LAND WEST OF HULBERT ROAD, HAVANT

Highways Response Note

HIGHWAYS RESPONSE NOTE

Re: APP/25/00573 At Land west of, Hulbert Road, Havant

P01	FIRST ISSUE			03.11.25	EK	SKB
Rev	Description		Date	By	App	
Date Created	Drawn By	Approved By	Suitability Code			
03.11.25	EK	SKB	-			
PBA Project Number		Scale				
020.0923		1:1000	(AT A3)			
PBA Drawing No:					Revision	
020.0923-0007					P01

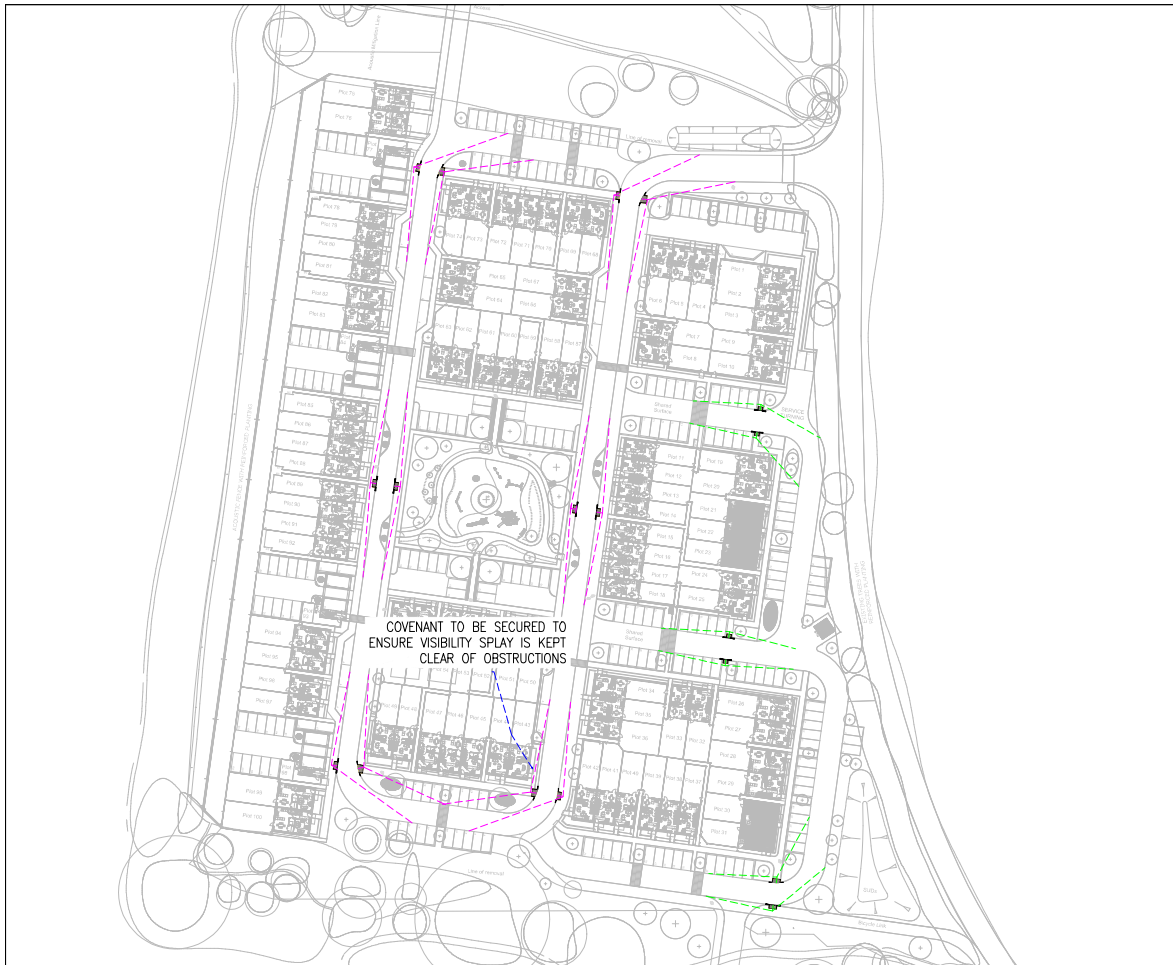
The Highway Authority request that a full geometric plan is provided showing dimensions across the site for carriageways, footways, cycle infrastructure and parking bays.

No dimensions have been provided and the remaining carriageway width as a result of buildouts needs to be specified to accord with TG10 requirements. Tracking has been provided for a car through the arrangement but not for the delivery vehicle. Tracking for a fire tender is also tight and with the associated tree planting may mean they cannot be navigated. The tracking should be provided for negotiating both features not just one for these larger vehicles at both proposed locations. There is also a build out arrangement on the most southern road running east west. Again, widths through this feature are unclear and forward visibility may be obstructed by landscaping.

- 2.3 HCC comments have requested that a geometric plan is provided showing dimensions across the site. This has been prepared and is included in **Appendix C**. This plan includes the widths of carriageways, footways, cycle infrastructure, parking bays, parking courts and widths through buildouts, which should address several points within this section.

- 2.10 As shown on the geometric plan included in **Appendix C**, the remaining carriageway width between the buildouts on the spine road is 3m. It is noted that the comments received from HCC state ***'No dimensions have been provided and the remaining carriageway width as a result of buildouts needs to be specified to accord with TG10 requirements'***. Following further review of TG10 and liaison with HCC officers, it is understood that the guidance for refuge islands applies to buildouts. As such, the guidance states (para 5.7.6) that *'It should either be wide enough to allow vehicles to safely overtake people cycling on the carriageway or narrow enough to discourage overtaking. Gaps between 3.2m and 3.9m shall be avoided. A minimum gap of 4m is recommended or alternatively gaps of 3.0 to 3.2m may be used provided that the route is not used by large vehicles such as Combine Harvesters.* With consideration to the guidance, the remaining widths of 3m should be acceptable.
